REMARKS

Favorable reconsideration and allowance of the present application are respectfully requested in view of the following remarks. Claims 1-18 were pending prior to the Office Action. Claims 19-26 have been added through this reply. Therefore, claims 1-26 are pending. Claims 1, 9, 12, 14, 16, 18 and 19 are independent.

AMENDMENTS TO THE DRAWINGS

CONVENTIONAL ART FIG.14A

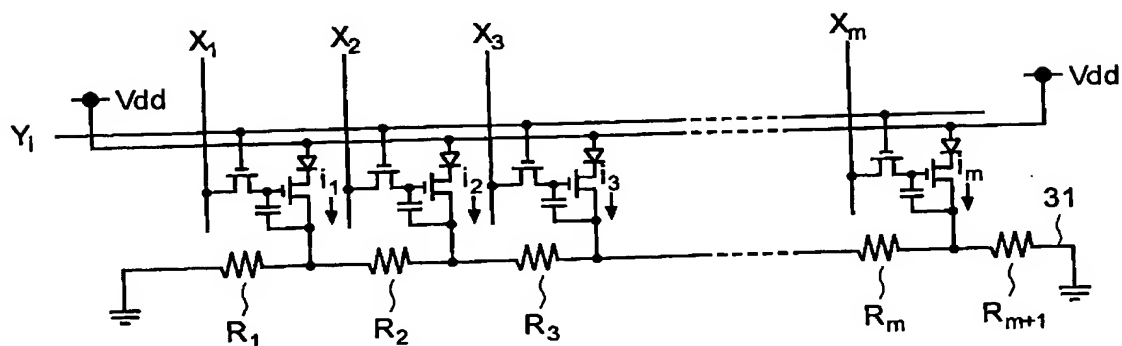
The drawings are objected to because it is alleged that Figures 13 and 14(a)-14(b) are not labeled correctly. *See Office Action, page 3, items 4 and 5.* The drawings have been amended to address this objection. Applicants request that the objection to the drawings be withdrawn.

- Figures 13 and 14(a)-14(b) are designated with the legend "Conventional Art" as required in the Office Action.
